SUSQUEHANNA STEAM ELECTRIC STATION  
MONTHLY OPERATING REPORTS  
PLA-4307 FILE R41-2A

PENNSYLVANIA POWER & LIGHT COMPANY  
SUSQUEHANNA STEAM ELECTRIC STATION  
OFFSITE DOSE CALCULATION MANUAL

## SUMMARY OF ODCM CHANGES

Document No.: OFFSITE DOSE CALCULATION MANUAL Revision: 3

FIGURE 1  
LIQUID RADWASTE SYSTEM FLOW DIAGRAM

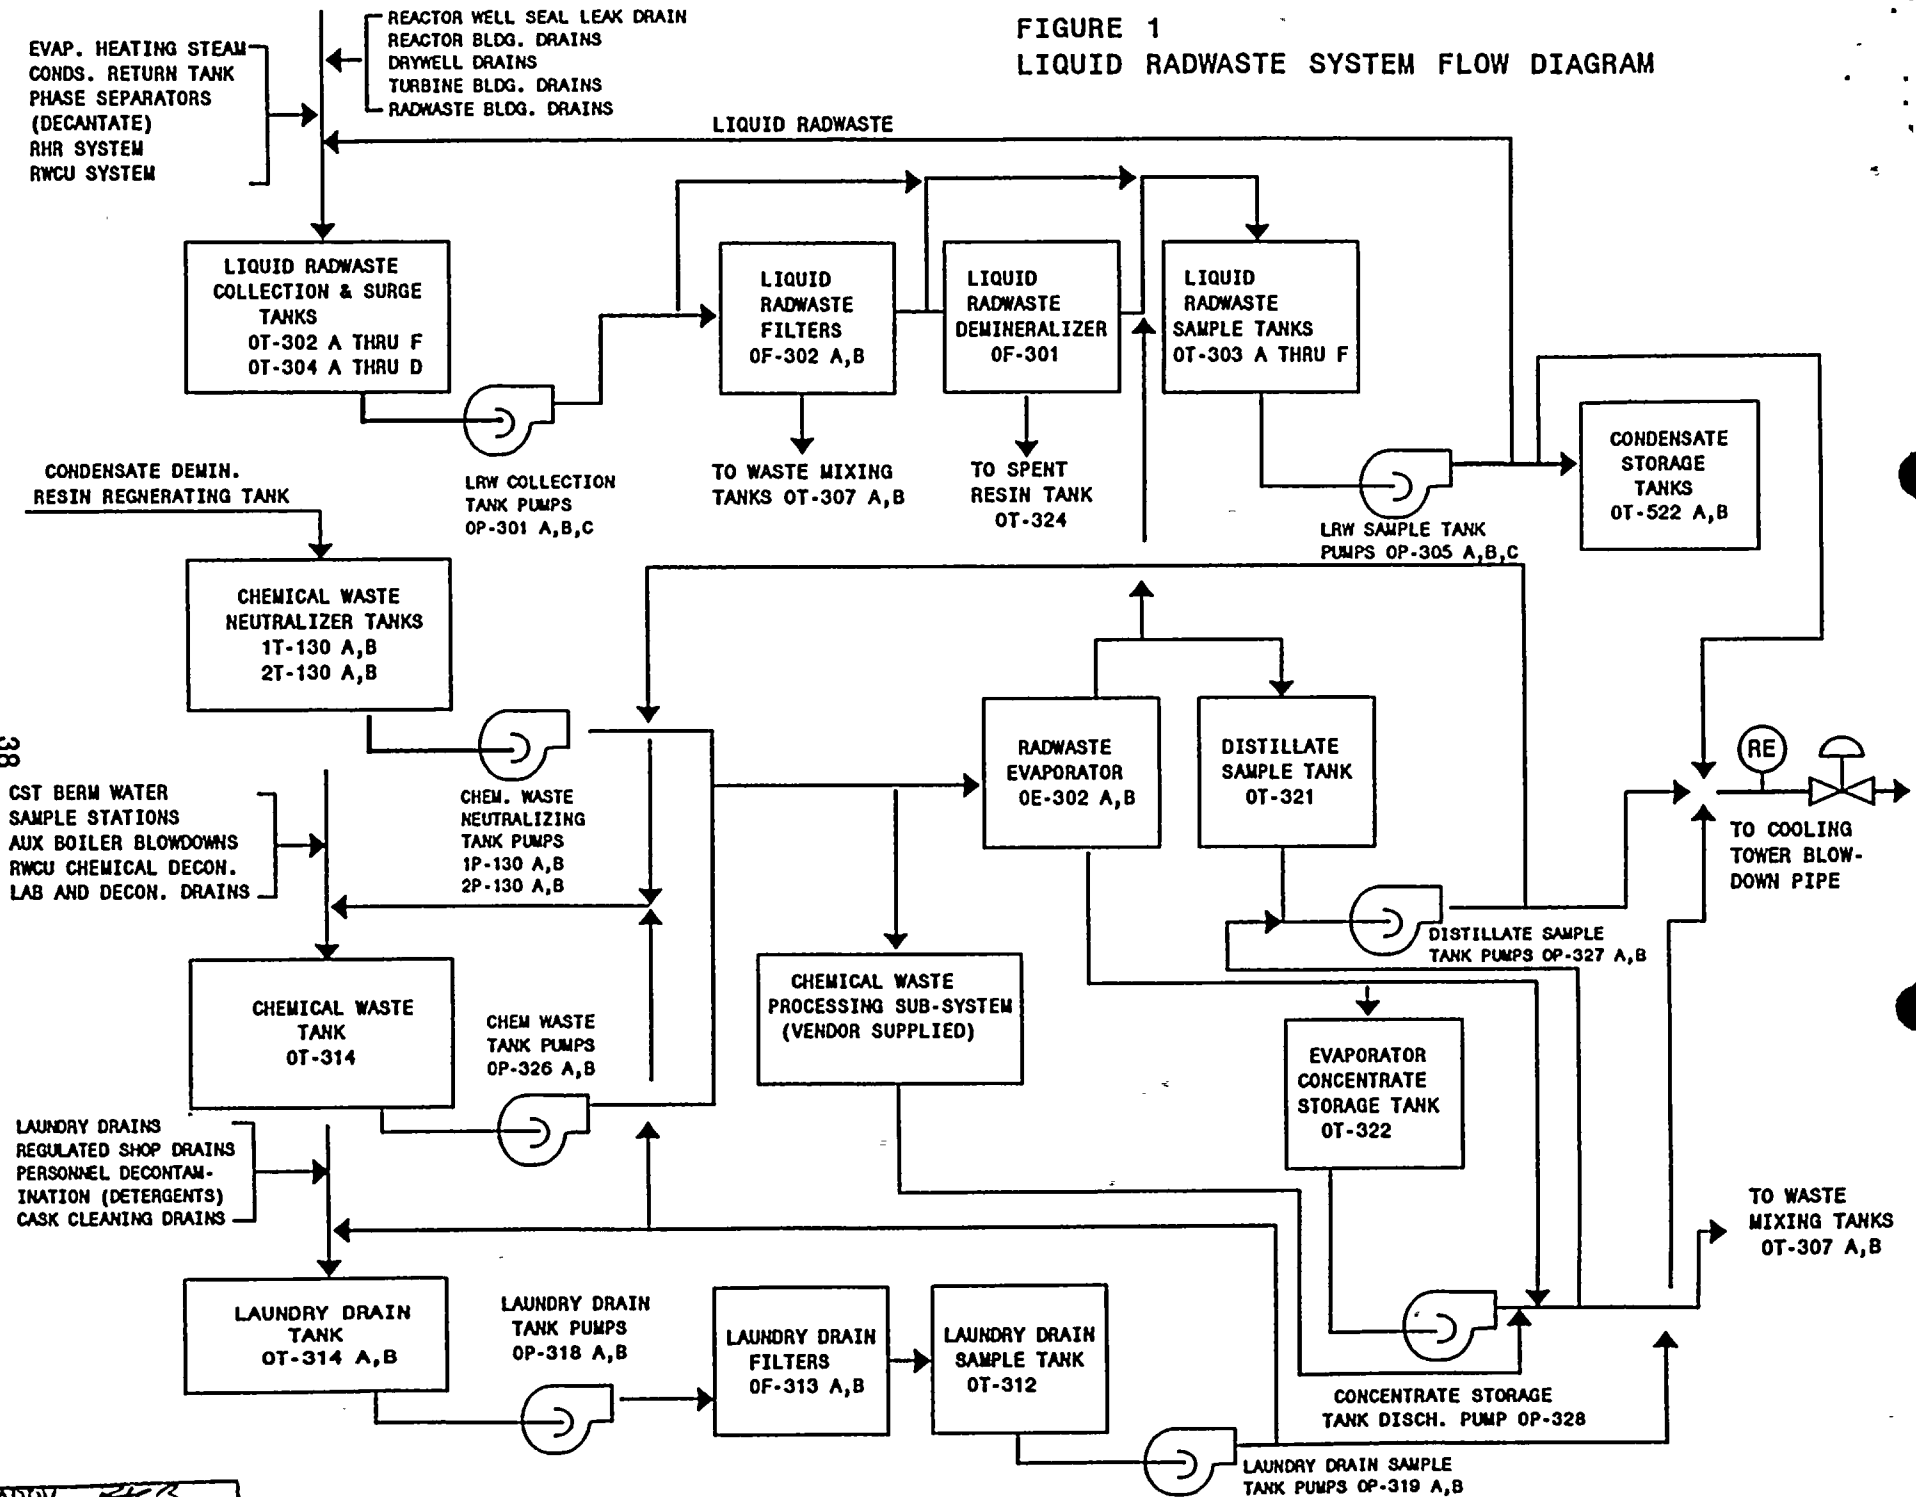
2. Slight changes are made to Figure 1, Liquid Radwaste System Flow Diagram, to make the pathway from the distillate sample tank to the cooling tower blowdown pipe clearer, and to correct labeling of distillate sample tank pumps OP-327 A, B and LRW sample Tank Pumps OP-305 A, B, and C.
